In addition to the general design requirements provided in **Appendix 15-A**, the following specific requirements apply:

Approved details for the Tensar ARES wall system are provided in the following plan sheets.

STANDARD ARES PRECAST PANEL RETAINING WALL DETAILS

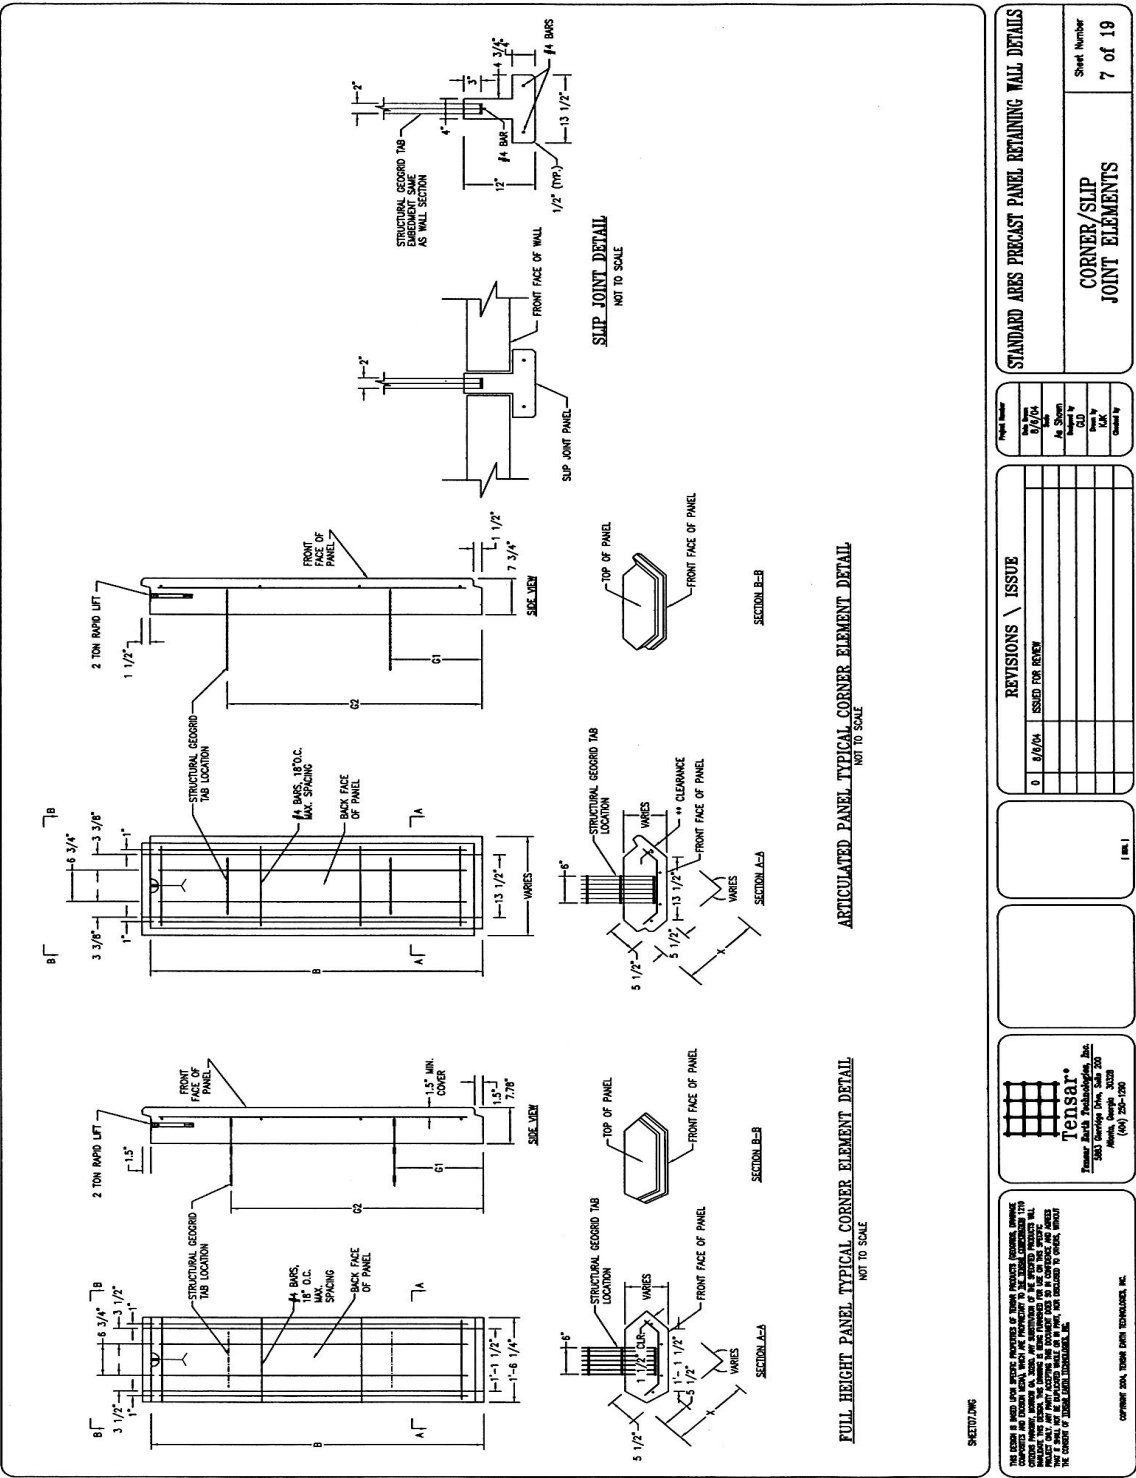
- For all plan sheets, the full height panel details are not preapproved. Full height panels may be used by special design, with the approval of the State Bridge Design Engineer and the State Geotechnical Engineer, provided a complete wall design with detailed plans are developed and included in the construction contract (i.e., full height panel walls shall not be submitted as shop drawings in design-bid-build projects).

- In plan sheet 3 of 19, there should be a minimum cover of 4 inches of soil between the geogrid and the traffic barrier reaction slab.
- In plan sheet 8 of 19, the strength of the geogrid and connection available shall be reduced by 10% to account for the skew of the geogrid reinforcement. The skew angle relative to the perpendicular from the wall face shall be no more than 10°.
